June 5, 2026

ADDENDUM NO. 2

Interim Fire Station No. 7

Specification No. 2025-010

TABLE 200-2.4.2

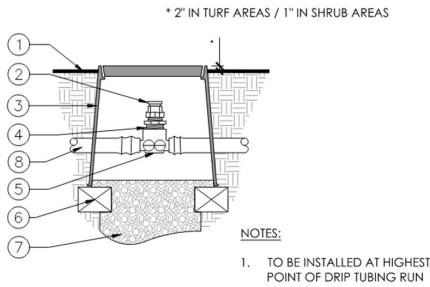
plans. They do not reference a specification?	
1-45	Can we use recycled base in the geogrid reinforced gravel raft? Specs only say 1 inch minus aggregate base in the Geotech report. No specific call out for natural or recycled base.	Recycled aggregate base can be used for the geogrid reinforced gravel raft beneath the structures. The recycled aggregate base should meet the requirements for CMB or PMB. Because the AB in the geotechnical report was recommended to be 1" minus material, the CMB or PMB should meet the coarse gradation requirements. See Table Below.

200-2.4.2 Grading. The material shall be uniformly graded and shall conform to one of the following gradations:

Sieve Size	Percentage Passing Sieve	
	Coarse	Fine
2" (50.0 mm)	100	
1-1/2" (37.5 mm)	85-100	100
3/4" (19.0 mm)	50-85	85-100
3/8" (9.5 mm)		55-75
No. 4 (4.75 mm)	25-45	35-60
No. 30 (600 µm)	10-25	10-30
No. 200 (75 µm)	2-9	2-9
ASTM C131 Test Grading	A	B

C DRIP AIR/ VACUUM RELIEF VALVE
N.T.S. P-M08-IRR-33

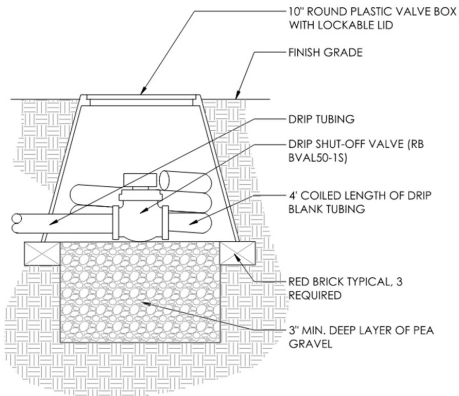
applied to the gate valve as shown in the legend. If not, please provide a detail for the specified gate valve.	
1-52	Please provide the model and detail installation for Air Relief Valve and Flush Valve as shown on detail A/ sheet 94.	Air Relief Valve: Rainbird ARV050, Flush Valve: Rainbird (RV BVAL50-1S) or Netafim TL5OV. Details provided for air relief and flush valve. See below:

- ① FINISH GRADE
- ② AIR/ VACUUM RELIEF VALVE, RAINBIRD (ARV050) OR EQUAL
- ③ 6" ROUND VALVE BOX
- ④ 3/4" MALE X 1/2" FEMALE REDUCING BUSHING
- ⑤ 180° 2-WAY ADAPTER TEE
- ⑥ BRICK SUPPORTS (3 TOTAL)
- ⑦ 3/4" GRAVEL SUMP (1 CUBIC FOOT)
- ⑧ DRIPLINE

One modification to the Air Relief Valve is for the AVR to be threaded into a PVC fitting, most likely a 90 degree at the end of the PVC run.

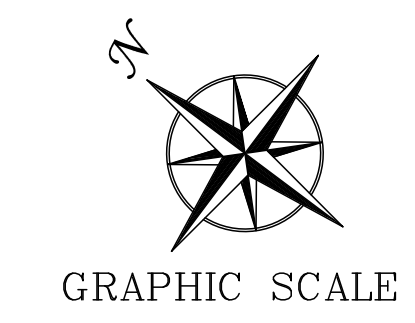
Sheet 6 OF 151, GRADING AND DRAINAGE PLAN

- 18-inch Reinforced Concrete Pipe (RCP) previously shown on Sheet 6 is revised to 6-inch PVC pipe.
- Added limit of work.
- Added limit of over-excavation.
